DATE OF DEFERRAL	26 November 2024
DATE OF PANEL MEETING	4 November 2024
PANEL MEMBERS	Justin Doyle (Chair), David Kitto, Louise Camenzuli
APOLOGIES	None
DECLARATIONS OF INTEREST	Kevin Lam and Ninos Khoshaba declared a conflict of interest as they voted on a site specific DCP in a Council meeting.

MATTER DEFERRED

PPSSWC-374 – Fairfield – DA 260.1/2023 – 402 Cabramatta Road, West Cabramatta - Construction of a 6-storey residential flat building comprising 87 apartments with two basement levels; construction of multi dwelling housing comprising 53 dwellings and 1 basement level; ancillary site works including demolition of existing structures, bulk earthworks, tree removal, construction of a private internal access road, amalgamation of existing lots and subdivision to create two new lots, landscaping and communal open space.

Figure 2 Site layout and building setbacks and Common Open Space

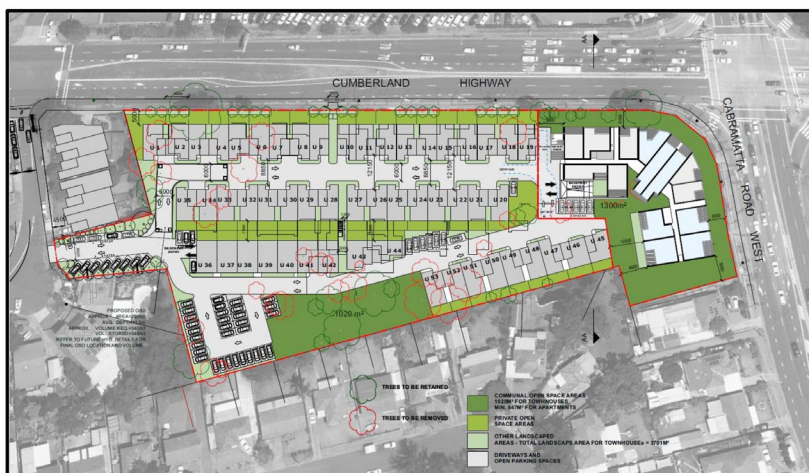
8. The DCP included at Figure 2 a layout plan depicting an anticipated residential flat building at the northern end of the site wrapping around the corner at the busy intersection of Orange Grove Road and Cabramatta Road. Multi-dwelling housing in the form of terraced townhouses was anticipated for the southern end of the site.

9. That Figure 2 is shown below beside a coloured drawing of the ground plan extracted from the material comprising the DA as lodged (noting that the DA scheme has subsequently been amended in some respects).

10. Because the rezoning of the land is specific and recent, and was arrived at through a process of public consultation the Panel has placed significant weight on that DCP which accompanied and presumably informed the amendment to Fairfield LEP. While there are some differences between Figure 2 and the scheme proposed in the DA, the Panel accepts that the DA design follows the overall proposal, layout and building form anticipated in the DCP. In coming to that conclusion, the Panel has reviewed the “Plan finalisation report – PP-2020-3237” which supported the rezoning and adoption of the site specific DCP anticipating 137 dwellings on the site including 84 apartments and 53 townhouses. The resolution to support the substantial upzoning was carried unanimously.

Excerpt of Fig. 2 of the SSDCP (Appendix G) with tree No's added to correlate with the Schedule of Assessed Trees (Appendix E).

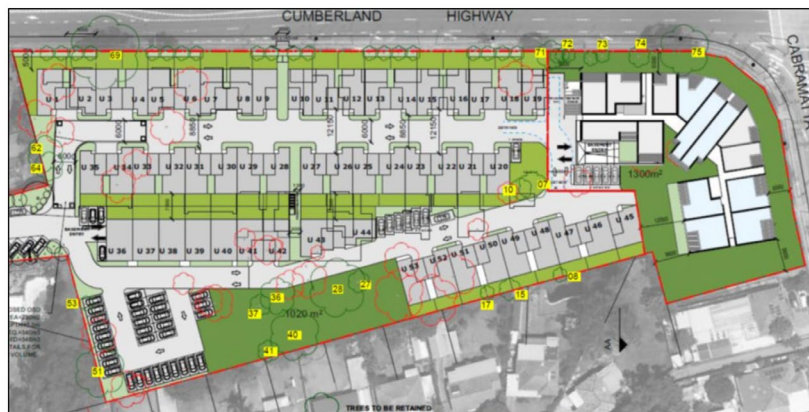
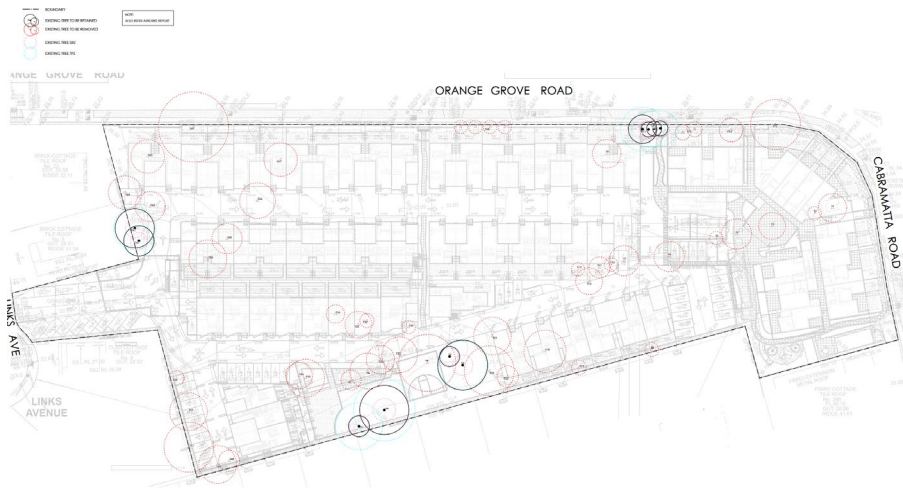
22. This is a comparison of the tree retention map included in the DCP (as marked up in the DA Arboricultural Impact Assessment with the numbers of the trees from the DA assessment) and the DA tree retention plan.

23. Tree 75 marked for retention in the DCP is of particular significance because of its prominence on the corner. However, the western side of tree 75 has been substantially pruned in the past with the result that the tree is not balanced in appearance. If the canopy on the eastern side of the tree is similarly pruned (as might be expected given the proximity of the residential flat building anticipated in Council's DCP) it seems that the appearance of the tree would be severely compromised. There is also observable damage to the footpath being caused by tree 75. The Arboricultural assessment does not address the practicality and consequences of retaining tree 75, but it is allocated a retention value of "High". If tree 75 is removed, smaller adjacent tree 74 (also marked in the DCP for retention) would be of a lesser value as being largely isolated. The Panel is sceptical about the long-term prospects of retaining tree 10 which is also marked in the plans for retention.

24. Having regard to those matters, the Panel members agree that removal of tree 75 (and consequently tree 74) is acceptable. That will reduce the existing presentation of trees to the corner of Orange Grove Road, but that is a consequence of the high-density zoning which Council has recently resolved is appropriate for this site.

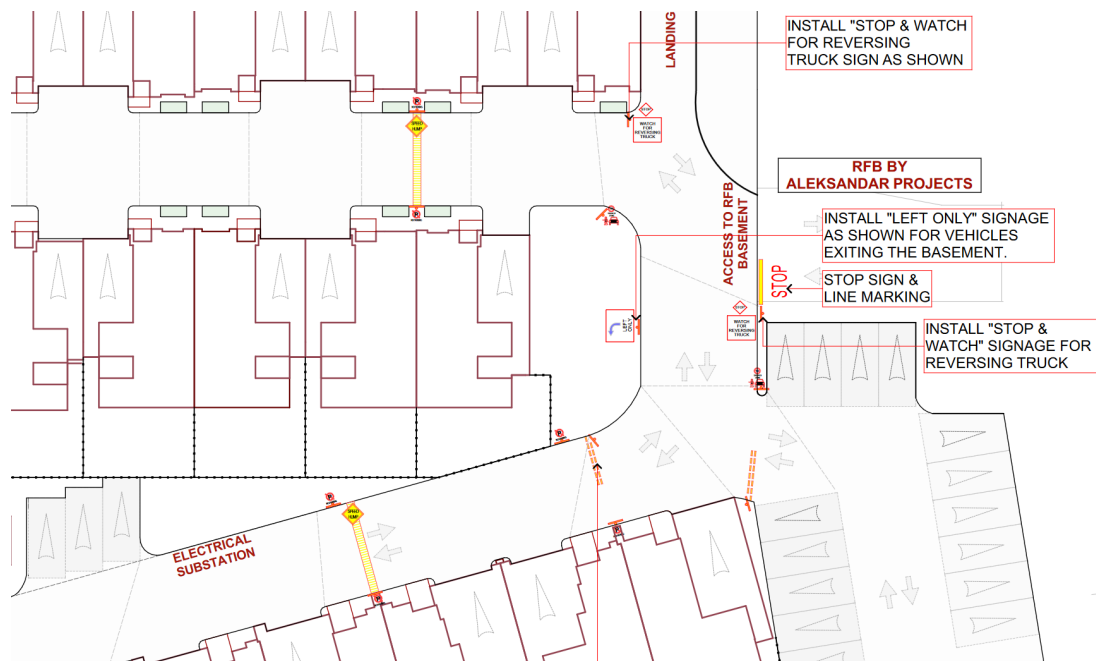
32. The Applicant's traffic consultant reports that the access driveway is to have a width of 7.7 metres, which is said to be adequate for a low volume (Category 1) access driveway in accordance with AS2890.1:2004, and will allow for waste collection truck access. The report states *"All vehicular manoeuvring within the site has been designed and checked using the HRV, B99 and B85 standard design vehicle turning paths from AS2890.1:2004, AS2890.2:2018 and Austroads."*

33. Council disagrees, reporting:

"Carriageway excluding curb is less than 6m in two locations (3m and 5.4m is proposed); carriageway including curb along the eastern road is less than 8.85 (6m is proposed); and carriageway width between units with garages opposite is less than 12.15m (as low as 9.6m)"

34. Notably, the driveway design does not allow a designated path for pedestrians separated from vehicular movements, even though the proposed parking arrangements along the drive and the location of the common open space anticipates significant pedestrian movements along the circular driveway. While the DA includes a 'Pedestrian Access & Mobility Plan' that plan does not consider pedestrian access and mobility for the access way within the site. The Applicant reports that *"The internal road incorporates measures to ensure pedestrian safety, including, surface treatments, speed limits, stopping restrictions, garage indentations, requirement for RFB traffic to turn right after entering to access the RFB, among others."*

35. The Panel expects that the driveway can be rendered acceptable, with some amendment, and a management plan to address pedestrian safety inside the site. It seems that deletion of one townhouse in the central band of townhouses is likely to be necessary to free up the manoeuvring of vehicles in the circular driveway particularly the 180 degree bend at its northern end. Given the drive is a shared way within a busy strata building with minimum tolerances for turning of trucks is not ideal, particularly coinciding with a substantial pedestrian entrance into the RFB, a loading dock and the ramp to the basement carpark. This detail from the plans shows the tightest section of the drive:

38. If that requires an update to the plans it might be facilitated by a deferred commencement condition, unless the Applicant can supply an amended drawing promptly.

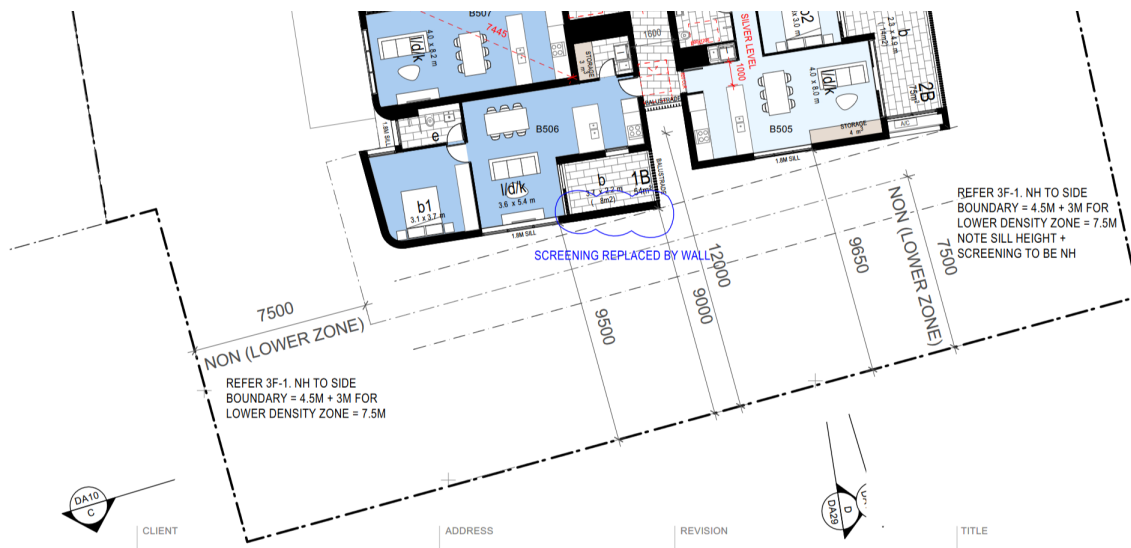
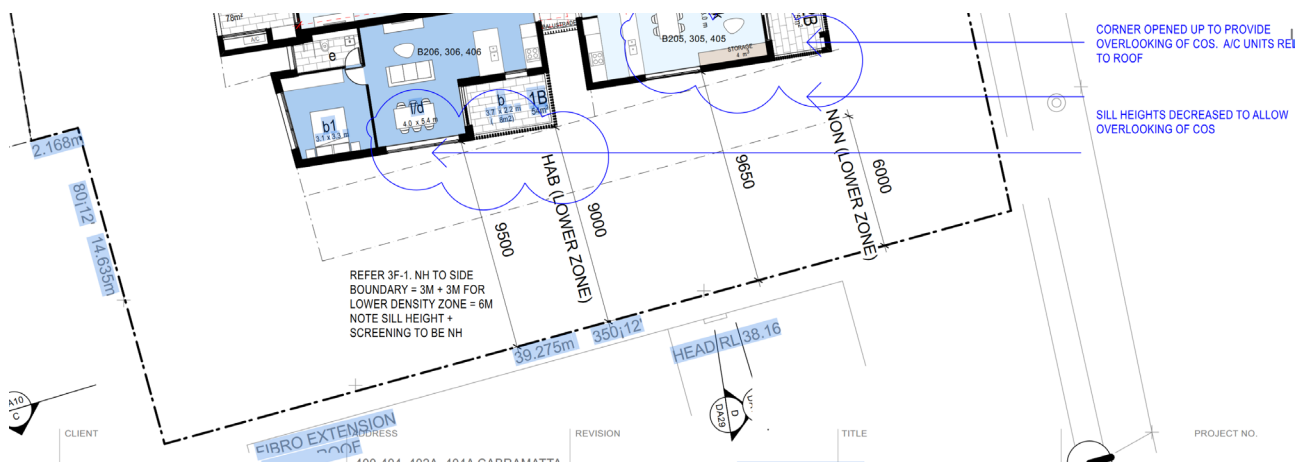
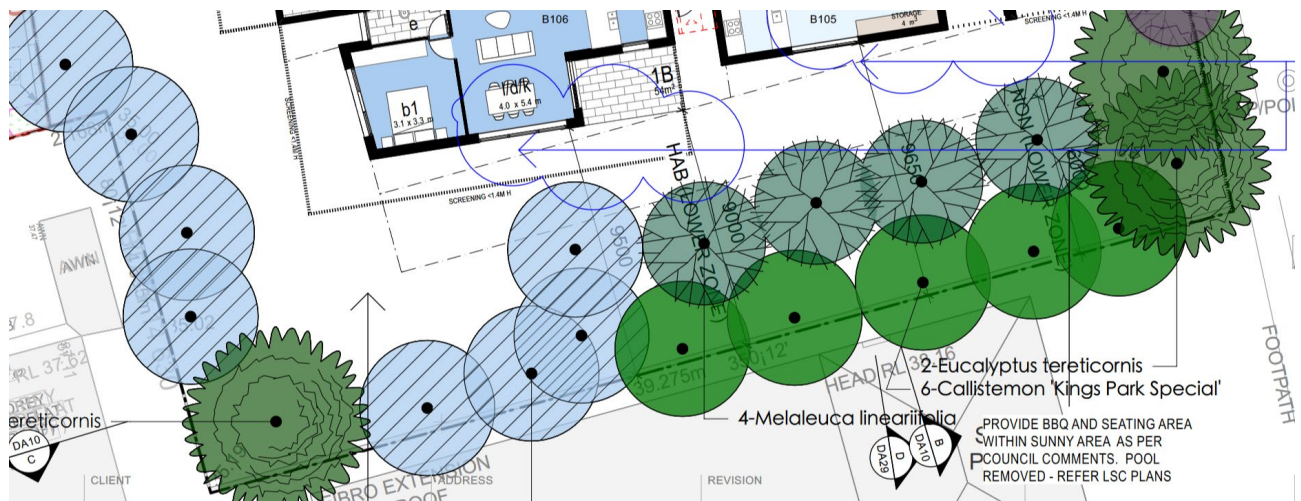
45. The only numeric dimension along the eastern boundary is 9 metres at its narrowest point, but the setback can then be seen in Figure 2 to increase consistently to around 11.5 metres. The line of the façade is straight. In contrast the DA steps the building setback with the result that at least one third of apartment B106 and the apartments directly above it project beyond the drawn setback of the eastern façade in Figure 2. However, the minimum setback in that location is still 9 metres. That stepping facilitates the inclusion of an extra one bedroom apartment in that location. This is the relevant part of the building at ground floor, first floor and second floor:

48. The Plans do not adopt the same setback as the Figure 2 plan, but do maintain the only dimensioned setback. The stepping along the boundary does result in a more articulated presentation with visual interest.

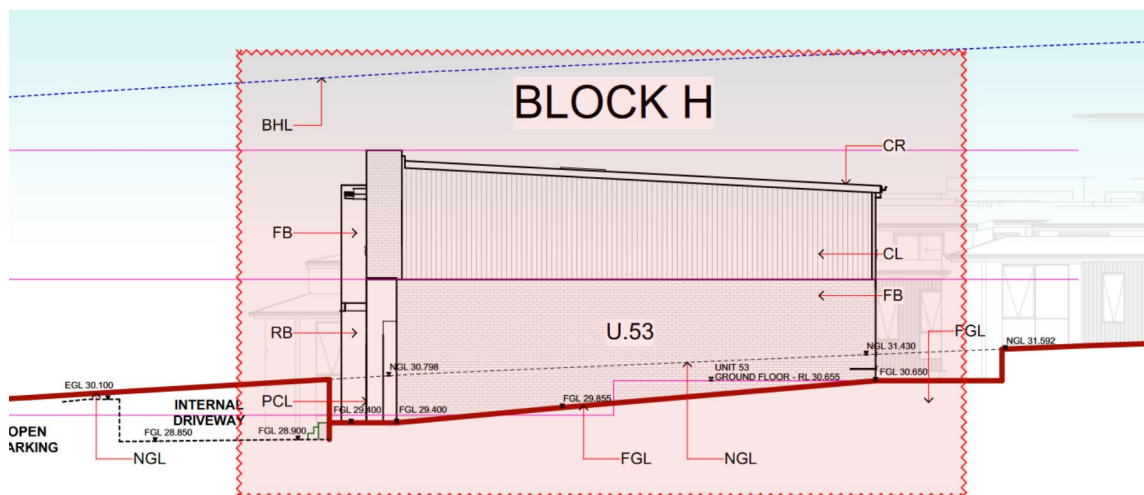
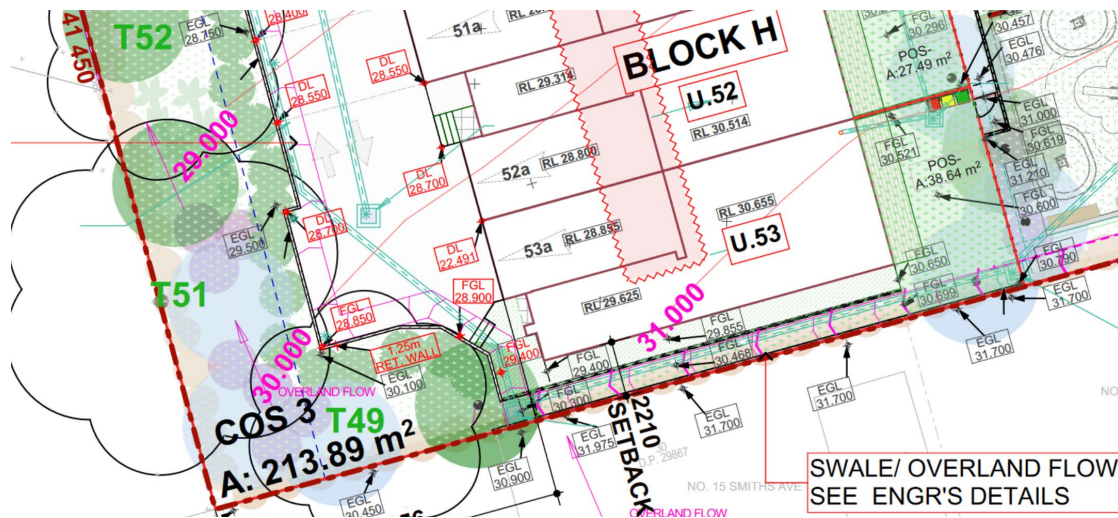
49. The Council commissioned an urban design report which reports a number of non-compliances with the ADG associated particularly with the more stringent setback controls that apply to the transition between the R4 and adjoining low density zone.

50. Taking all of those matters into account, the assessment of the eastern setback is finely balanced.

51. Ultimately, the Panel sees the staggered and stepped element in the building design as a positive design feature which ought to be retained.
52. However, there are significant design problems with the single bedroom apartments squeezed in at that location. The first floor level has windows which will look straight into the backyard of the adjoining property producing a poor amenity outcome. The second floor apartment B506 has a small balcony surrounded entirely by presumably fixed louvres to prevent overlooking. It has three external openings which do not allow an outlook – a 1.8 metre high clerestory window facing east, a door out onto the entirely screened balcony, and a slot window for the bedroom which looks into the corner of the adjoining apartment.

53. The Panel's considered conclusion on the eastern façade is:
- (a) Apartments B206, B306, and B406 ought to be amalgamated with the adjoining apartment so that the combined 2 bedroom apartment will have a living area which allows a reasonable outlook and cross ventilation. Apartment B106 which does not have the screening issues can be retained. That layout is notably closer to the layout in the DCP indicative scheme.

- (b) The existing footprint which adopts the 9 metre staggered setback can be retained on the basis, that the high level of architectural detailing shown in the DA plans (such as the subtly curved south eastern corner which softens the transition between housing types) is retained in construction.

- (c) Windows above the ground floor in the eastern façade (including the first floor) ought to be clerestory or suitably screened to prevent overlooking.

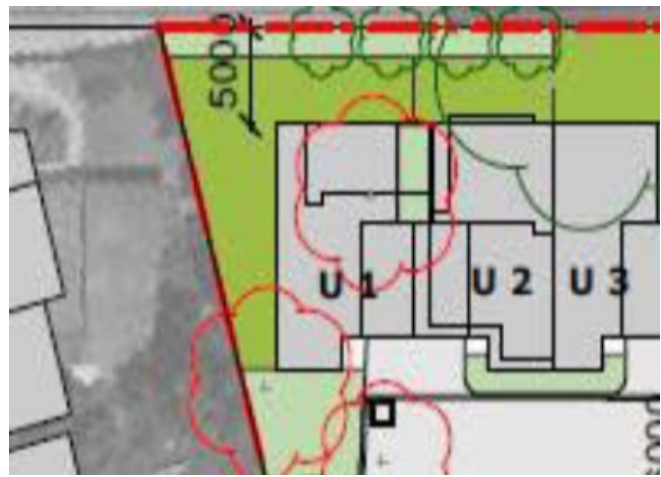
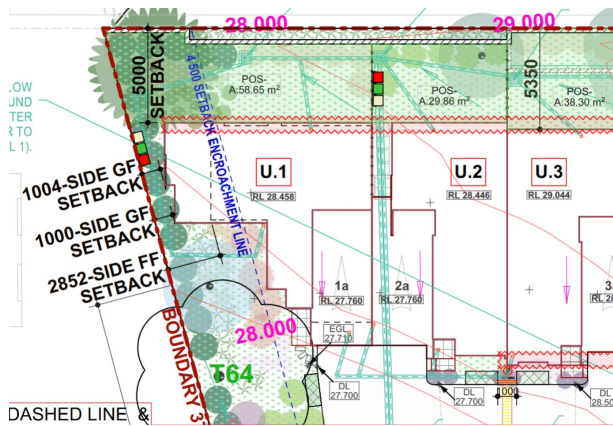
61. Block H (for which a setback of 2.21m is dimensioned) was not anticipated in the DCP Figure 2 layout, because that built form has been swapped with the parking now adjacent to the residential flat building at the other end of the site. The Panel has therefore considered those setbacks carefully. The building is not proposed to be screened by trees because of the drainage swale. The building is however partly excavated into the ground level to lower the height, and has no openings. It is not adjacent to another building. These are details from the plans in that location:

62. Ultimately taking all of those matters into account the Panel concluded that the setback for Block H was acceptable.
63. The final issue of concern was the one metre setback of the ground floor to the southern boundary of Lot 1, but with the first floor setback 2.852 metres. The images below compare the DCP layout and the DA proposal.
64. Ultimately the Panel was satisfied that while the layout is different, the overall setback outcome is maintained or improved. The Panel is particularly pleased to see that tree T64 can be preserved (although the DCP allowed for its removal).
